**PLANNED UNIT DEVELOPMENT
& SUBDIVISION STAFF REPORT****Date: January 18, 2018**

<u>DEVELOPMENT NAME</u>	Westwood Plaza Subdivision, Burton Addition to, Resubdivision of Lot B-R, Resubdivision of B and E
<u>SUBDIVISION NAME</u>	Westwood Plaza Subdivision, Burton Addition to, Resubdivision of Lot B-R, Resubdivision of B and E
<u>LOCATION</u>	7765 Airport Boulevard (Southeast corner of Airport Boulevard and Schillinger Road South, extending to the North side of Thomas Road)
<u>CITY COUNCIL DISTRICT</u>	District 6
<u>AREA OF PROPERTY</u>	2 Lots / 17.0± acres
<u>CONTEMPLATED USE</u>	Planned Unit Development Approval to amend a previously approved Planned Unit Development to allow shared access and parking between multiple building sites; and Subdivision approval to create two legal lots of record.
<u>TIME SCHEDULE FOR DEVELOPMENT</u>	No time frame provided.
<u>ENGINEERING COMMENTS</u>

APPLICANT Westwood Plaza Subdivision, Burton Addition to,
Resubdivision of Lot B-R, Resubdivision of B and E

REQUEST Subdivision, Planned Unit Development

SITE PLAN

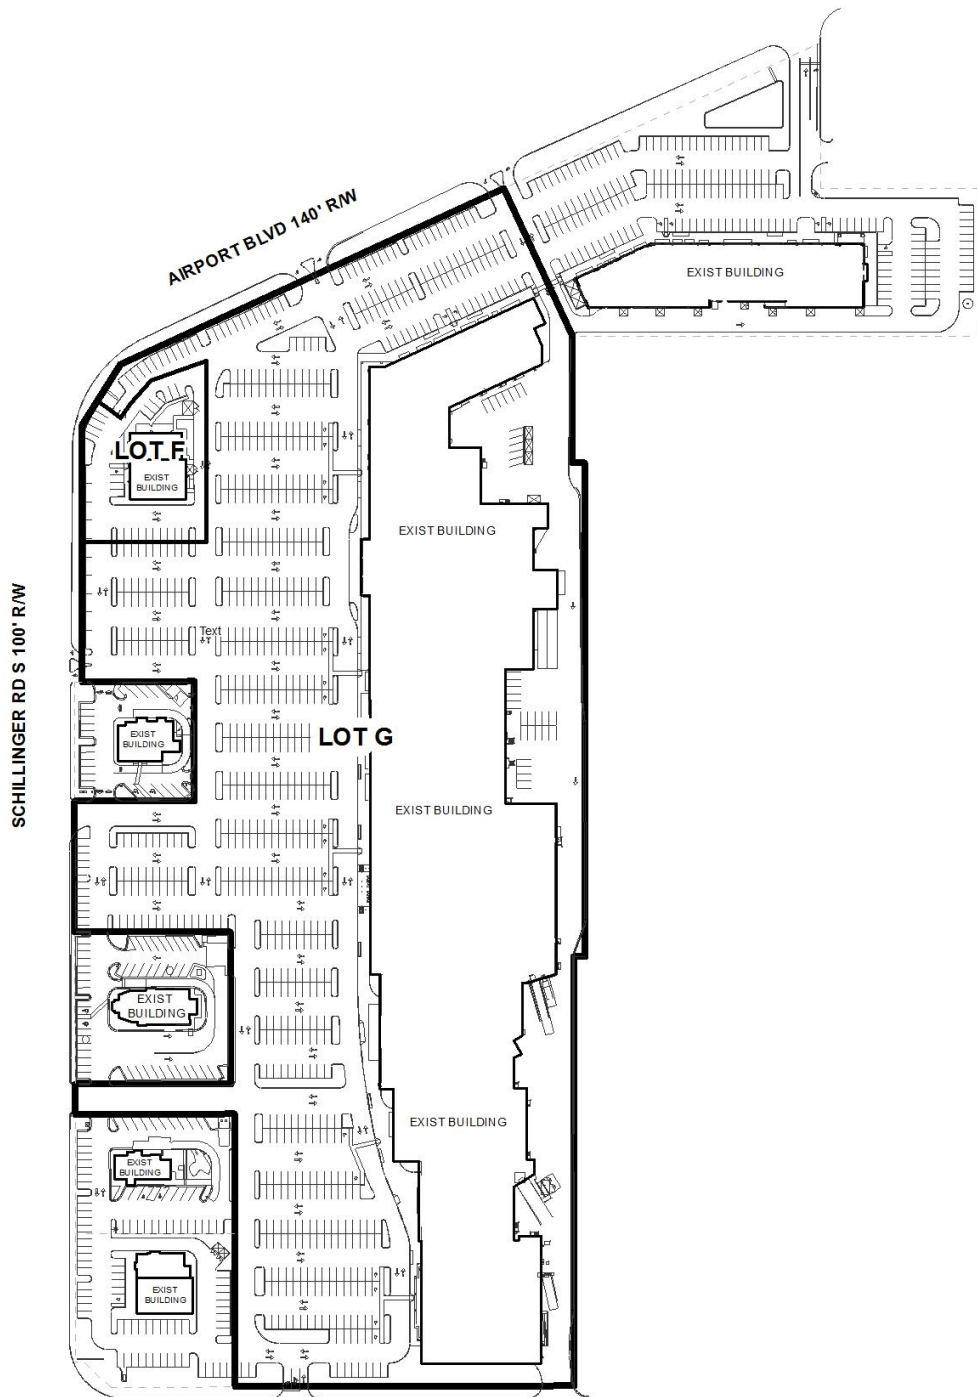
The site plan should be revised to indicate the existing required public sidewalk along Thomas Road. As waivers were granted at the May 1, 2014, Commission meeting, sidewalks are not required along Schillinger Road South or Airport Boulevard.

site plan. The preliminary plat labels each proposed lot with its size in both square feet and acres and should be retained on the Final Plat, or a table should be furnished on the Final Plat providing the same information. The PUD site plan, however, only labels proposed Lot F with its size. Therefore, the site plan should be revised to also label proposed Lot G with its size in both square feet and acres, or a table should be furnished on a revised site plan providing the same information.

- 3) revision of the site plan to indicate the existing required public sidewalk along Thomas Road;
- 4) retention of the 25' to 35' minimum building setback line along all street frontages;

- 5) revision of the site plan to also label proposed Lot G with its size in both square feet and acres, or the furnishing of a table on the site plan providing the same information for both Lots G and F;
